7.7 Control Systems Not Required for Safety

The information in this section of the reference ABWR DCD, including all subsections and figures, is incorporated by reference with the following departures and supplements.

Figure 7.7-11 Simplified Functional Diagram of the Automatic Power Regulation System

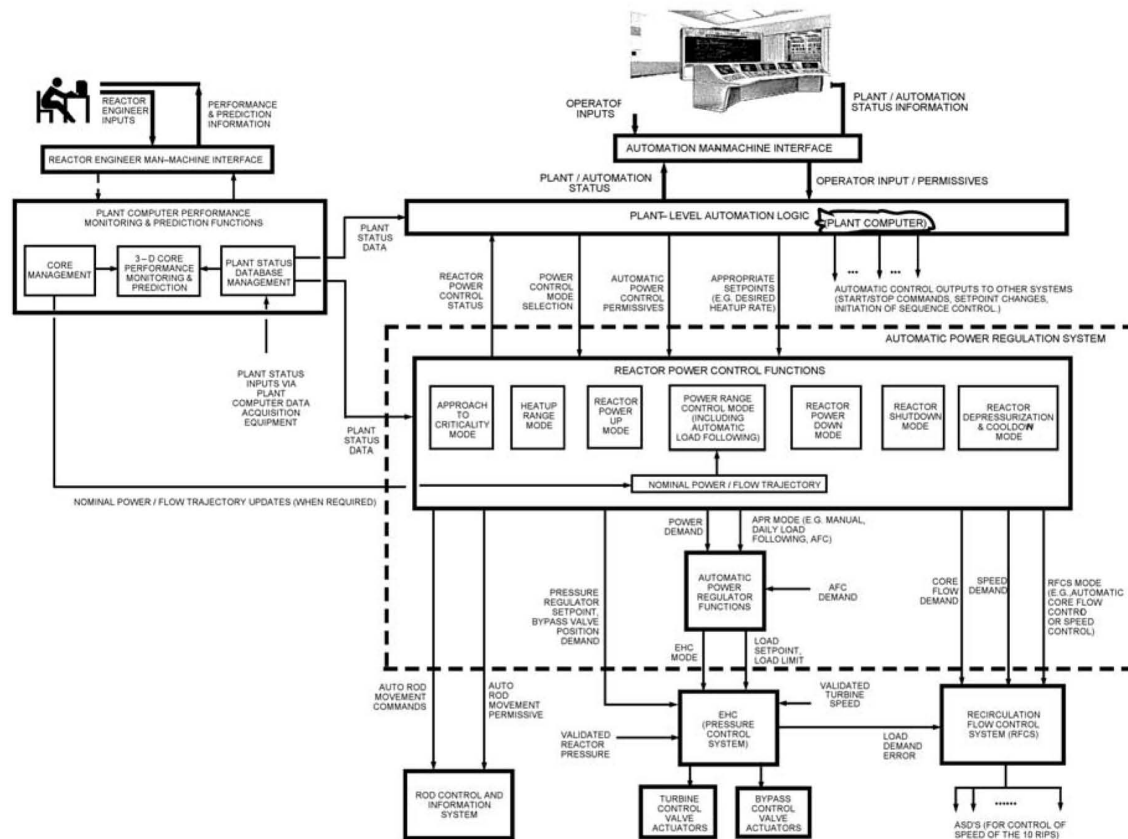
STD DEP T1 3.4-1 (Figures 7.7-4, 7.7-5, 7.7-8, 7.7-11)
